**Patent No.:** 7,071,557 B2

**For:** METALLIZATION STRUCTURES  
FOR SEMICONDUCTOR DEVICE  
INTERCONNECTS, METHODS FOR  
MAKING SAME, AND  
SEMICONDUCTOR DEVICES  
INCLUDING SAME

**REQUEST FOR CERTIFICATE OF CORRECTION OF PATENT  
OFFICE MISTAKES (37 C.F.R. § 1.322)**

## UNITED STATES PATENT AND TRADEMARK OFFICE CERTIFICATE OF CORRECTION

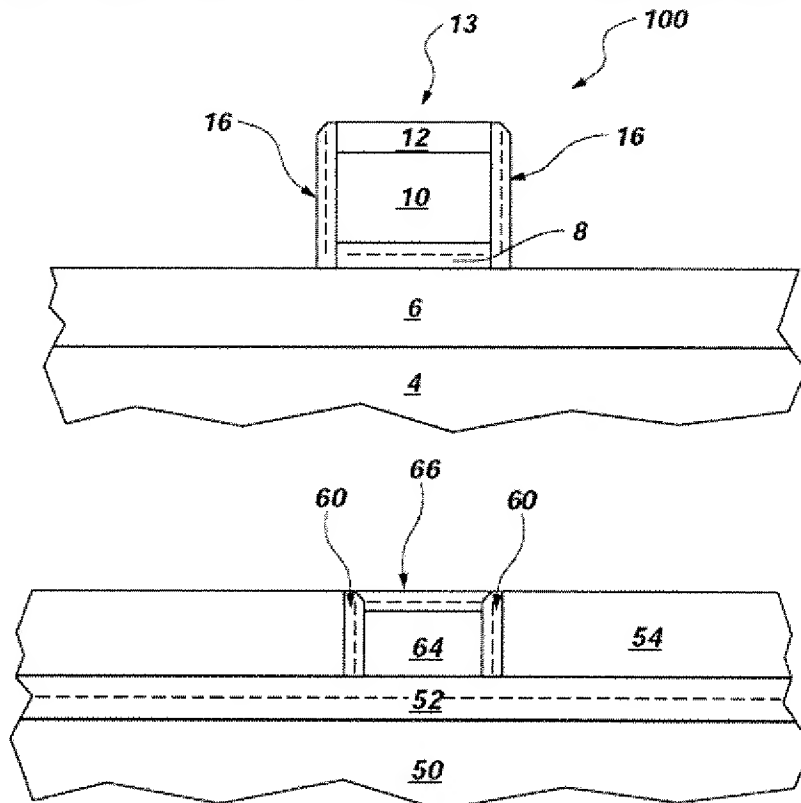
Replace the existing annotated figures at the bottom of the page with corrected formal drawings submitted June 26, 2001

**Fig. 3a**

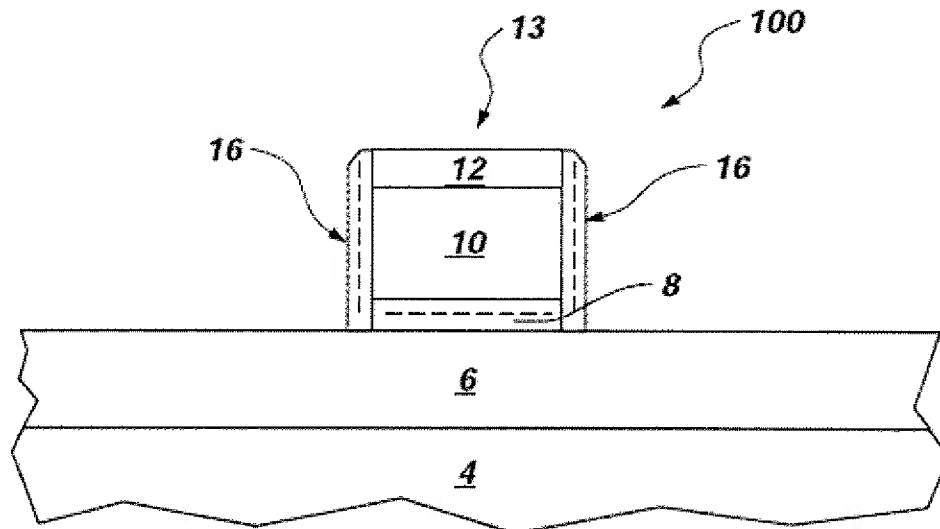
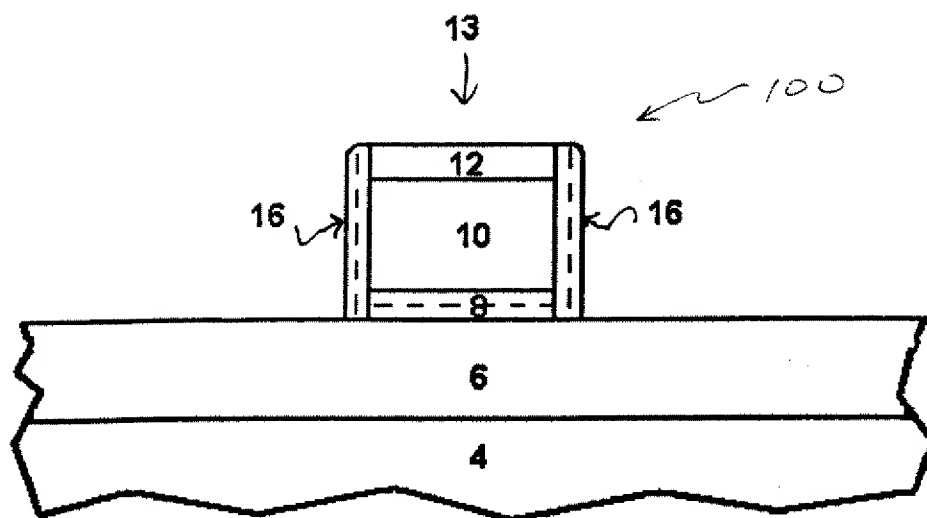
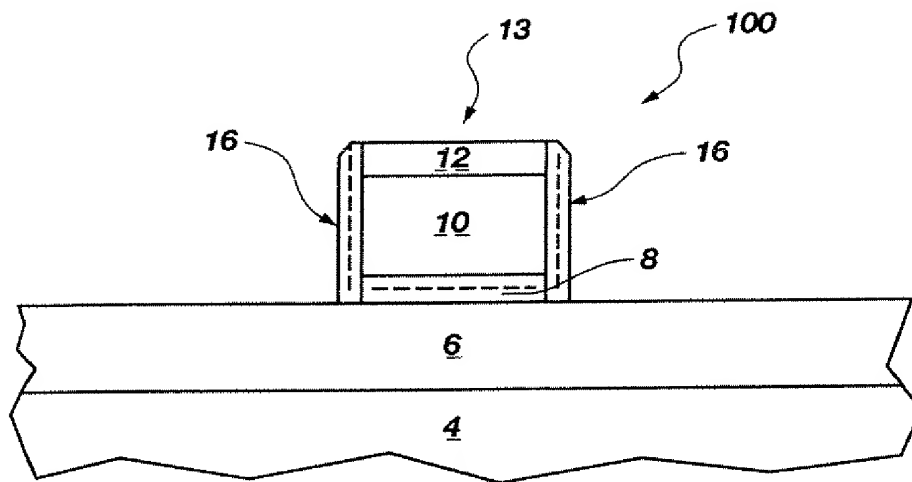
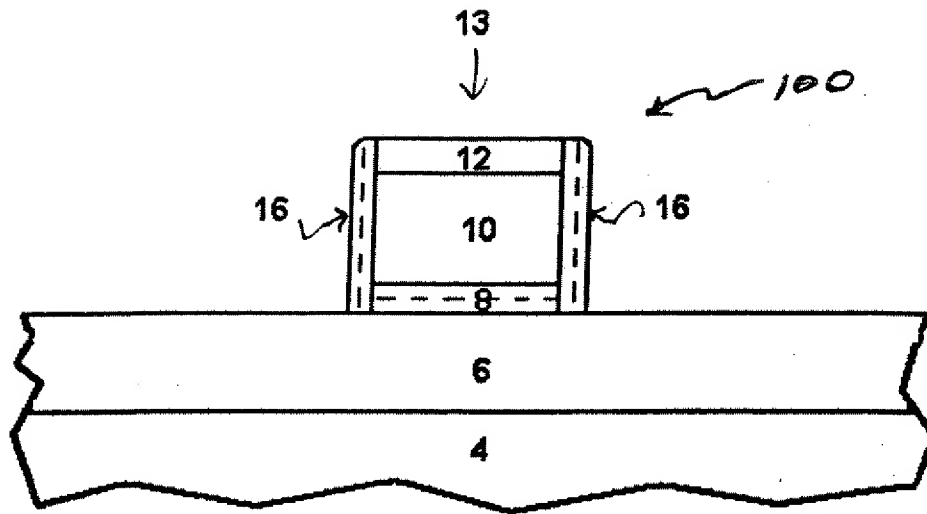
Figure 3a

Replace the existing annotated figure with the corrected formal drawing submitted June 26, 2001

**Please replace Fig. 3a with the following replacement figure:**

Applicant submits herewith revised FIGS. 3a, 3b and 5 which correct errors in the drawings. Specifically, FIGS. 3a and 3b have been revised to add the reference numeral 100 with appropriate lead lines; and FIG. 5 has been revised to add the reference numeral 62a.

**Fig. 3b**

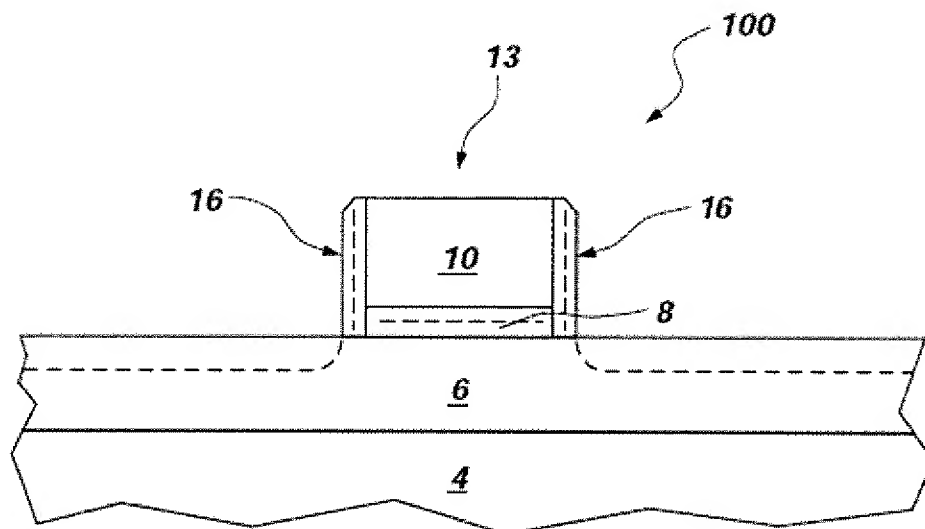
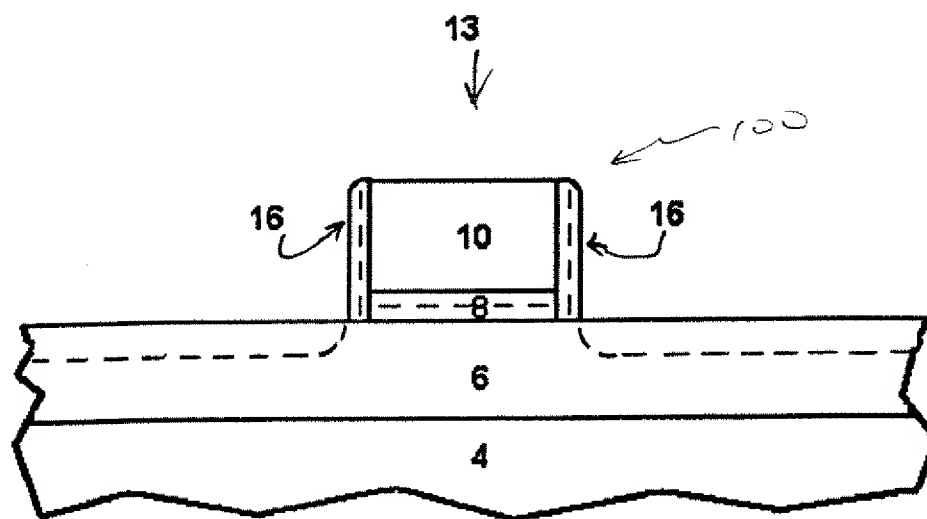
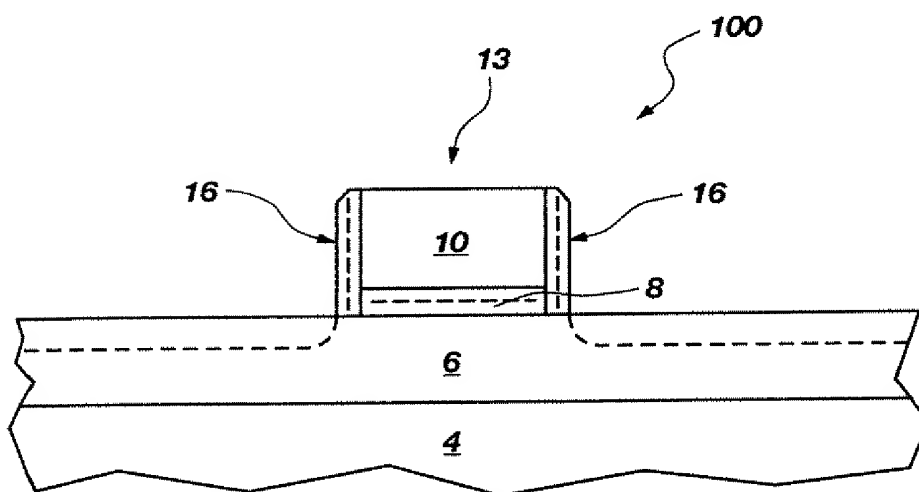
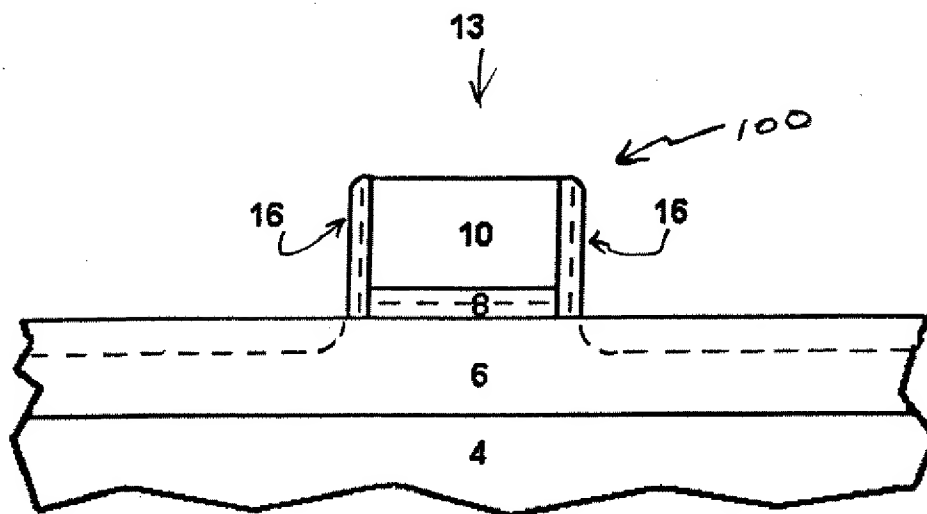
Figure 3b

Replace the existing annotated figure with the corrected formal drawing submitted June 26, 2001

**Please replace Fig. 3b with the following replacement figure:**

**Fig. 5**

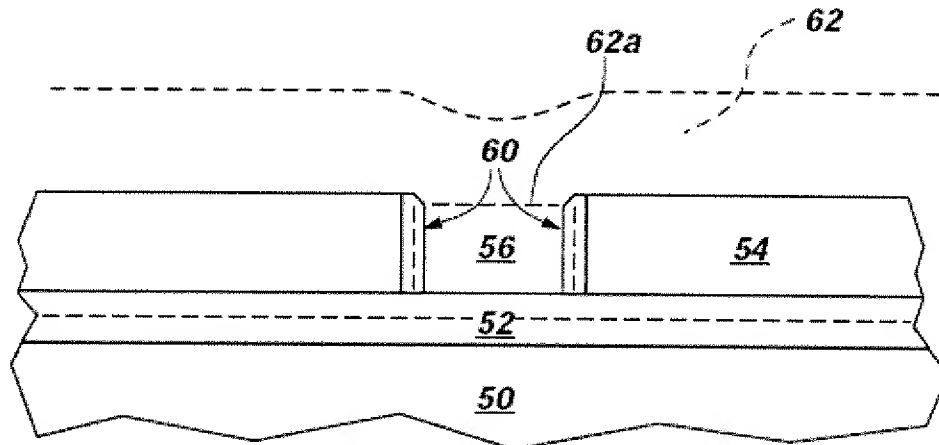
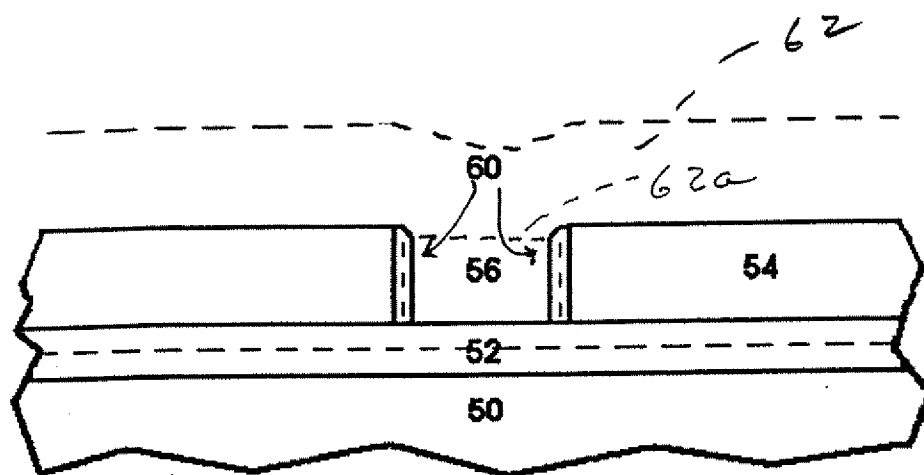
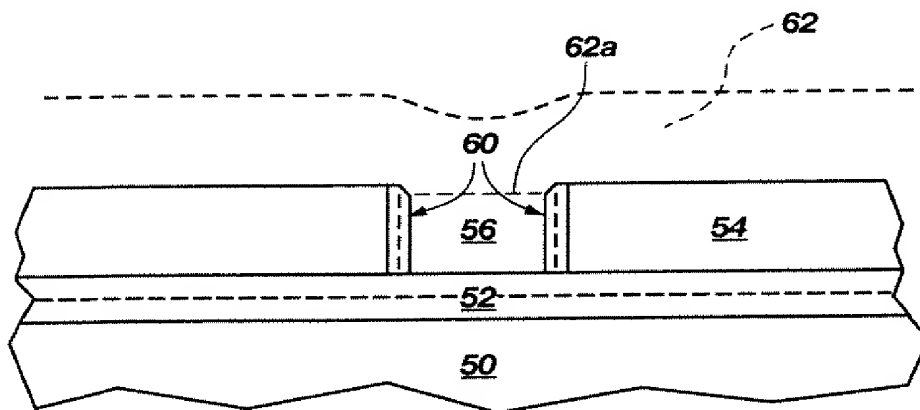
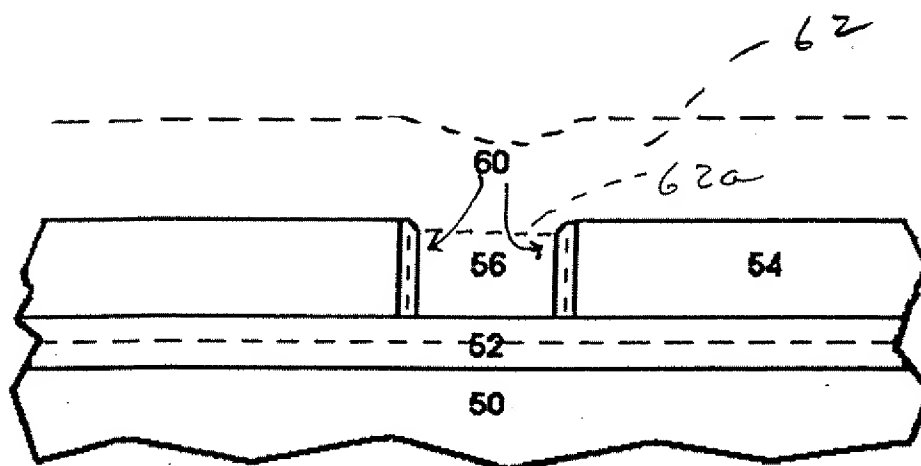
Figure 5

Replace the existing annotated figure with the corrected formal drawing submitted June 26, 2001

**Please replace Fig. 5 with the following replacement figure:**

The drawings have now been objected to by the Examiner for failing to mention "element 62a." This drawing objection has been overcome by the enclosed copy of the above-identified Letter to the Chief Draftsman filed on August 4, 2000, a copy of the date-stamped postcard also being included herewith to evidence receipt of same by the Office. Applicant's undersigned attorney has recolored the proposed corrections on the copies of the revised drawings to assist the Examiner. Otherwise, the paper is as previously filed. Review and approval of the proposed revisions to the drawings is respectfully requested. Applicant will file a corrected set of formal drawings upon an indication that the proposed revisions are approved.
